**ARCHITECT'S SUPPLEMENTAL INSTRUCTIONS**

JONES GILLAM RENZ DOCUMENT JGR 710

<b>PROJECT:</b>	The Reserves at Grand View Heights New Development Laramie, Wyoming	<b>Report No.</b>	Eight (8)
<b>OWNER:</b>	Overland Property Group Dan Maximuk 250 N. Santa Fe Ave, Suite A Salina, KS 67401	<b>Date</b>	April 22, 2025
<b>CONTRACTOR:</b>	Overland Construction Group 250 N. Santa Fe Ave, Suite A Salina, KS 67401	<b>Architect's Proj No.</b>	22-3262
		<b>Contract For:</b>	General Construction Mechanical, Electrical

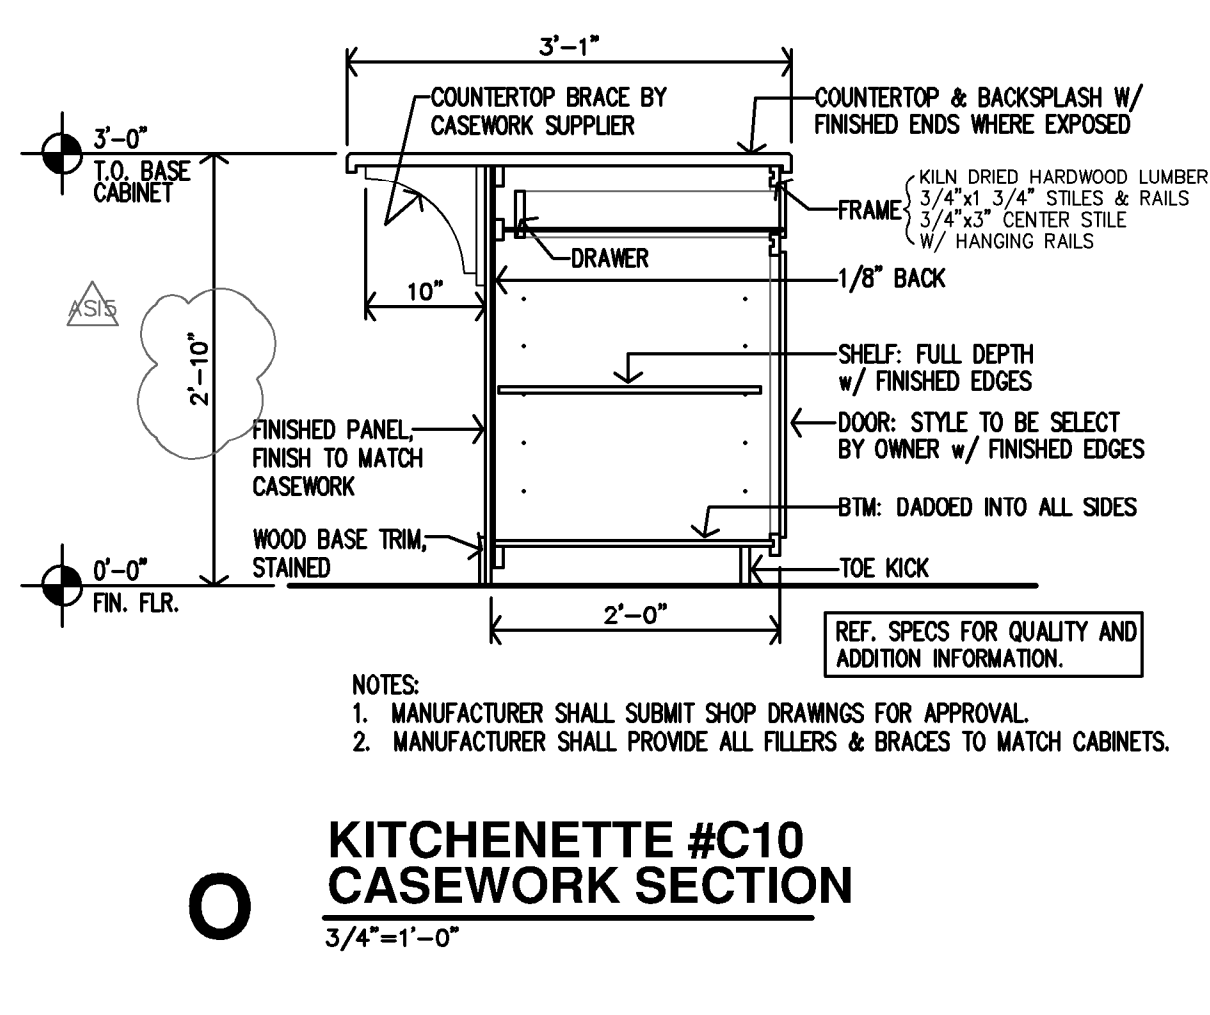
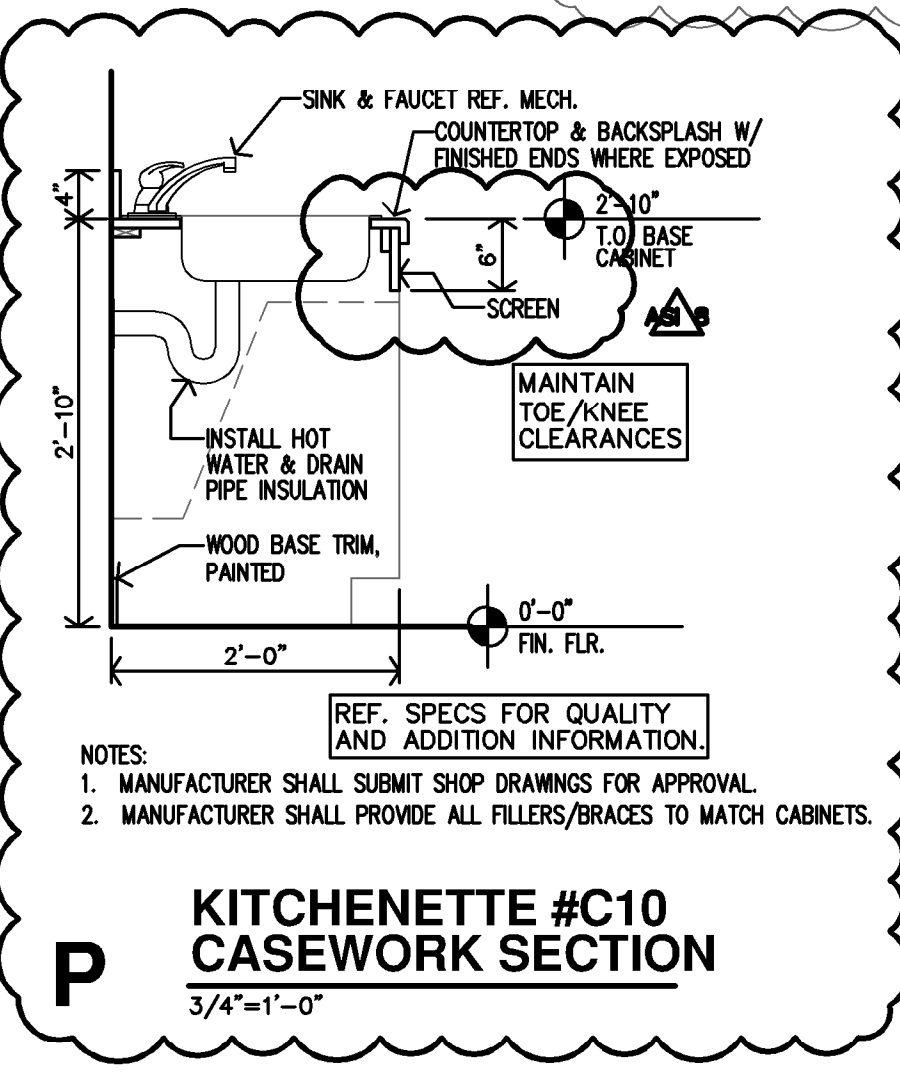
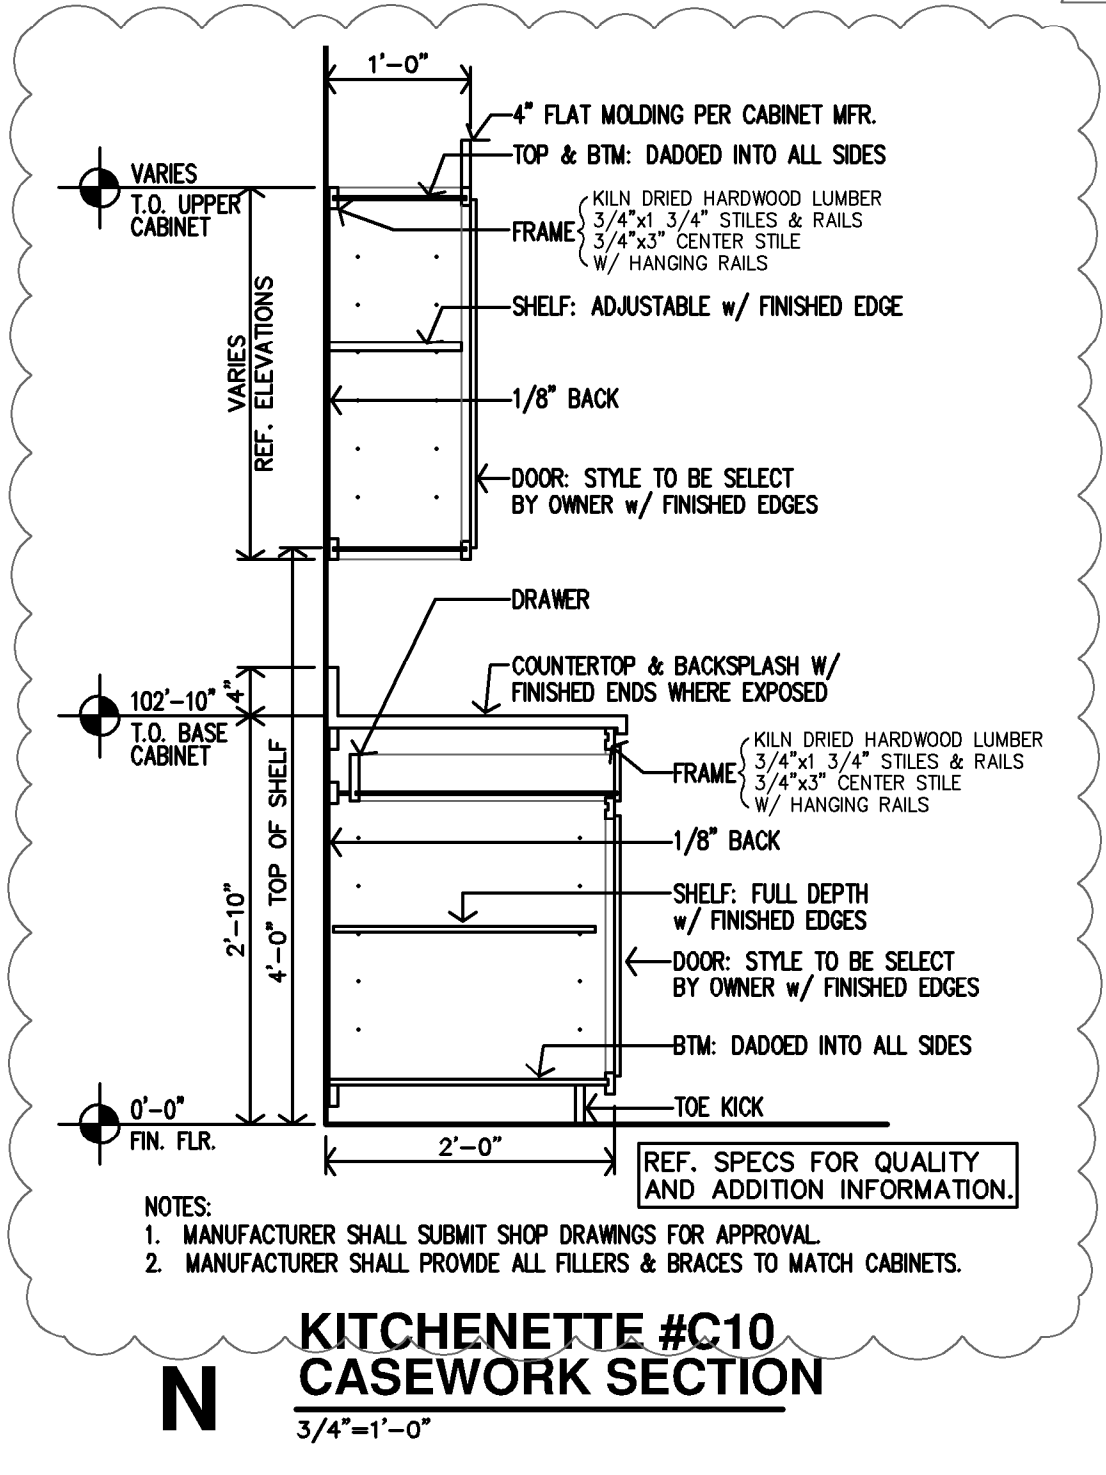
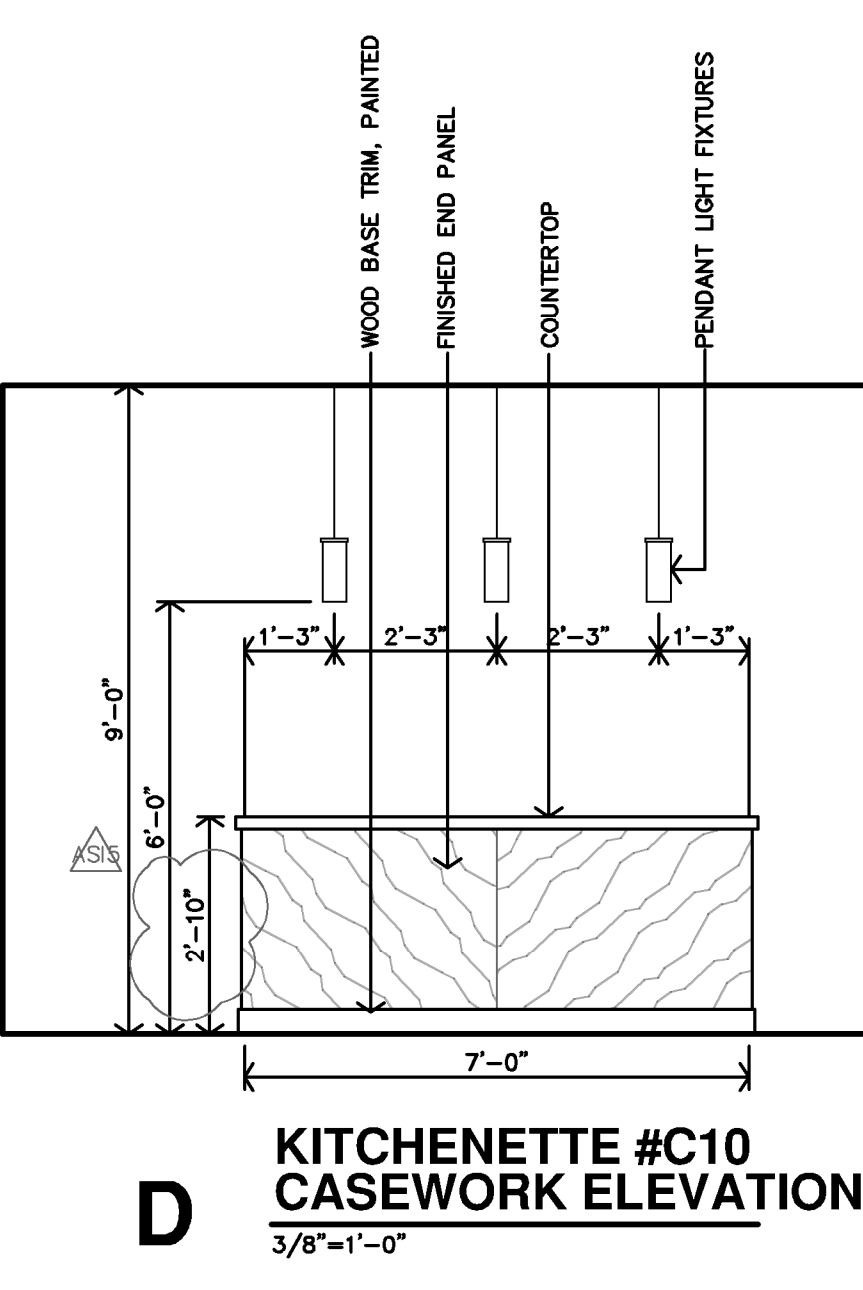
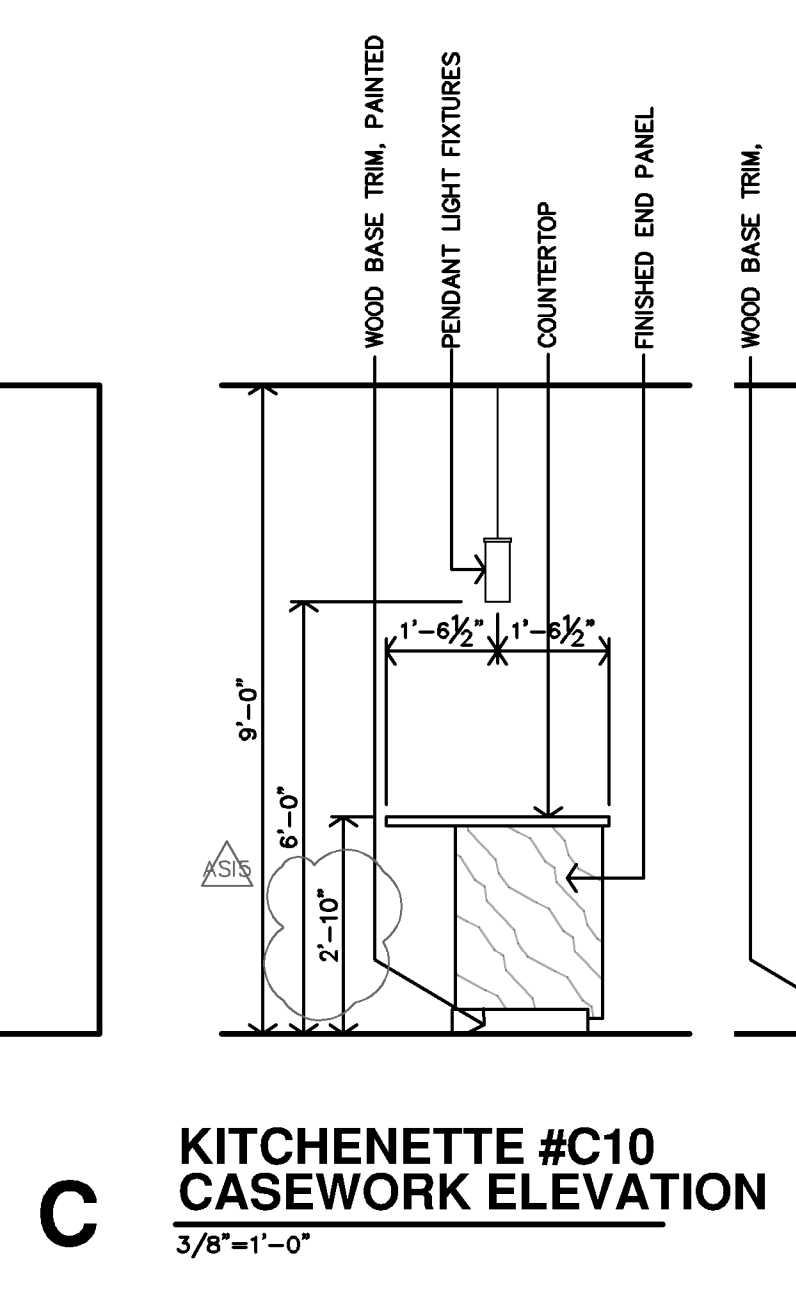
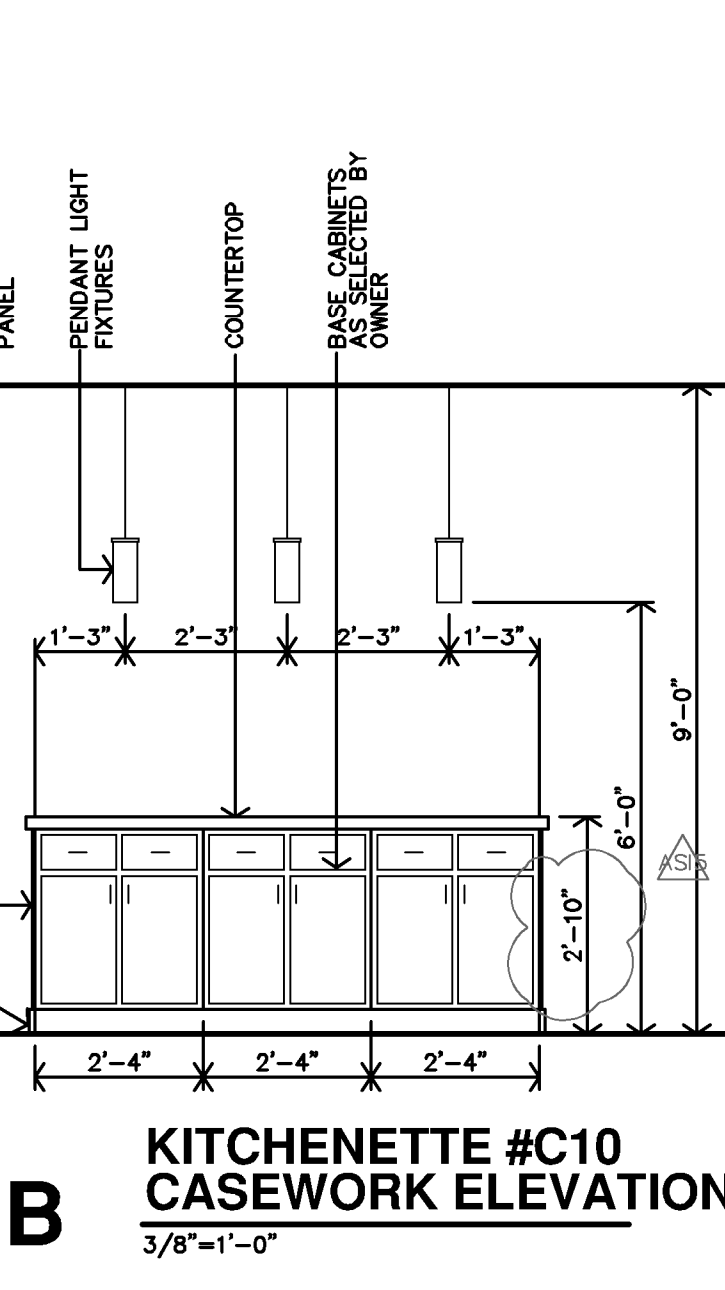
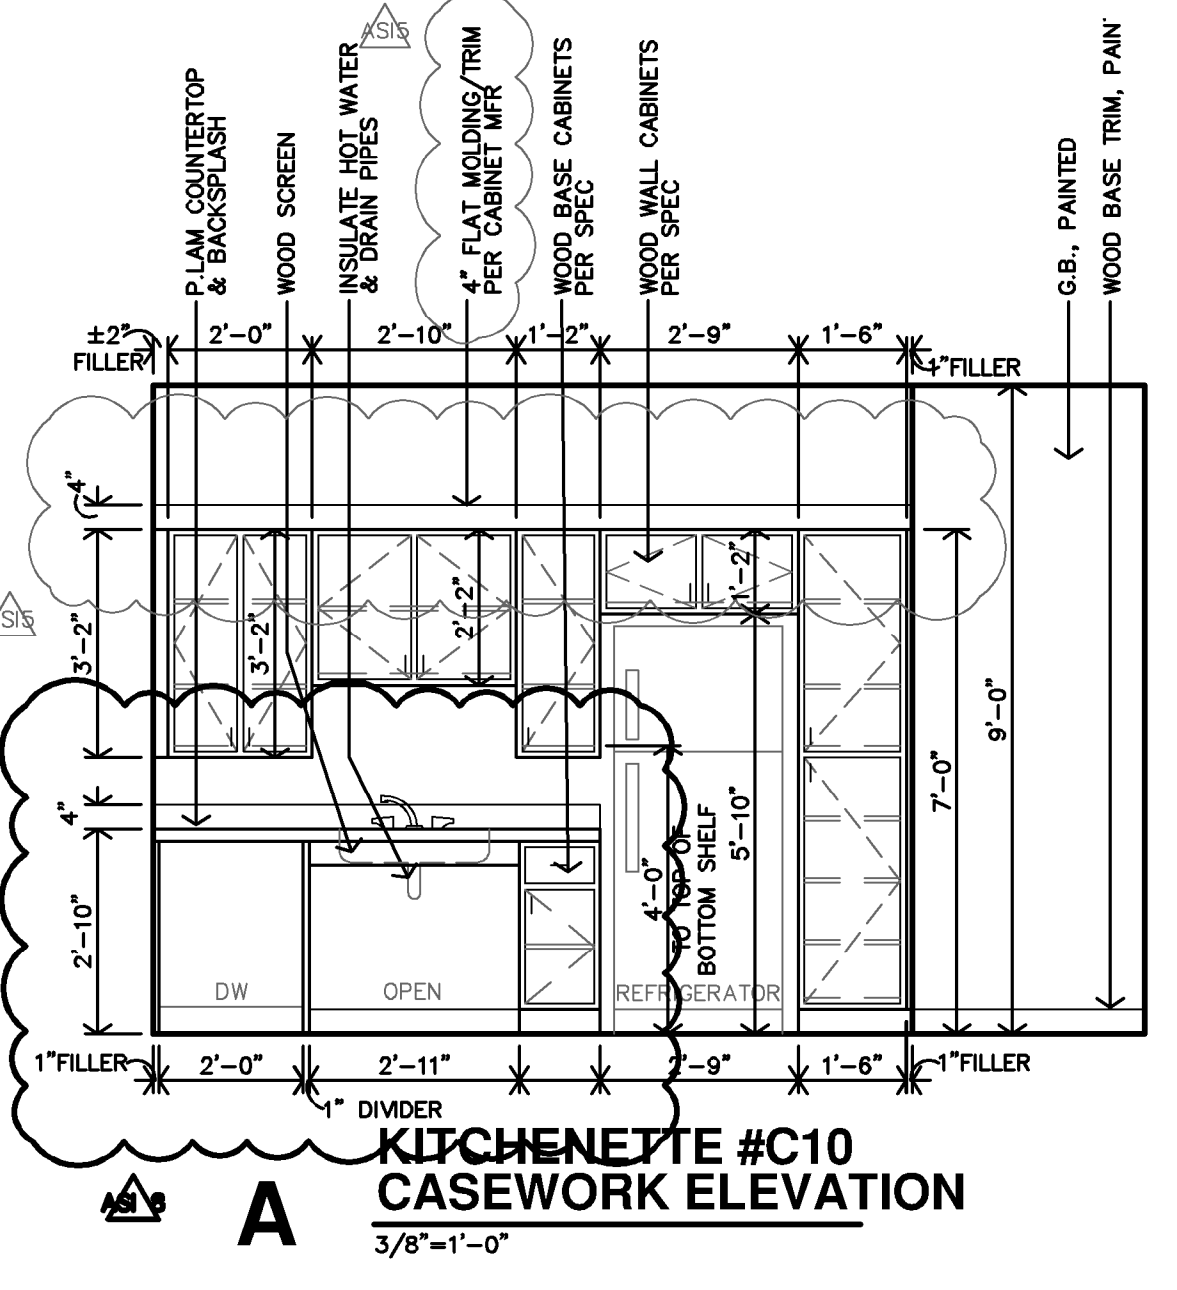
- 1) Sheet A2.11
  - o Detail A – Kitchen sink to have roll-under approach. Cabinet below sink has been removed. Add divider next to dishwasher.
  - o Detail P – Added detail. Add 6" screen below countertop.
- 2) Sheet ME – added ceiling radiation dampers to main supply duct and mech room diffuser
- 3) Sheet P1.1 – revised kitchen sink & lavatory B107
- 4) Sheet P1.3 – revised kitchen sinks in A101 and A102.
